Submission to the public exhibition of Heritage Park Landscape Master Plan

Comment (draft) Heritage Park Master Plan

SUBJECT: HERITAGE PARK LANDSCAPE MASTER PLAN

Submission on the Draft Heritage Park Master Plan

40 Heritage Park Masterplan

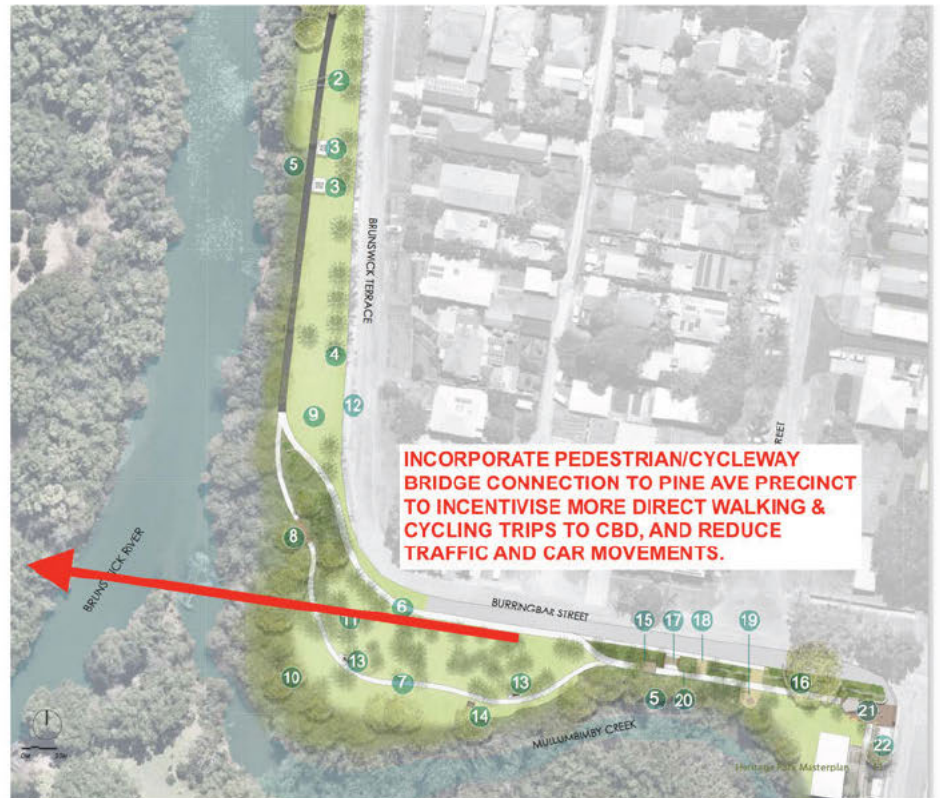
While we acknowledge the bridge to the Pine Ave Precinct would be a large and expensive undertaking, we believe it should still be allowed for and incorporated into the Heritage Park Masterplan, in case the funding were to become available in the future.
